**Amendments to the Drawings:**

**REMARKS**

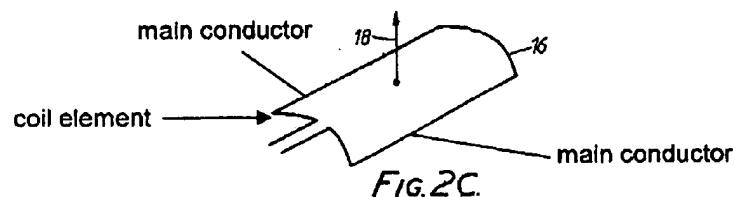
The undersigned then directed the Examiner's attention to the fact that applicants' independent Claim 1 refers to "electrically separate" coil elements, not to electrically connected coil elements. With reference to Fox's Figures 1, 2A, 2B, and 2C, the undersigned further explained that each of Fox's four coil elements has two main conductors. Significantly, the main conductors of those coil elements are not located on "opposite sides" of the space in which the magnetic field is generated as required by Claim 1. Rather, as set forth at column 5, lines 19-22, of Fox and as shown by the following annotated copy of Fox's Figure 2C, these main conductors are separated by 120°:

As such, the main conductors of Fox's coil elements are clearly not opposite to one another as called for by Claim 1, as well as by applicants' other independent claims.
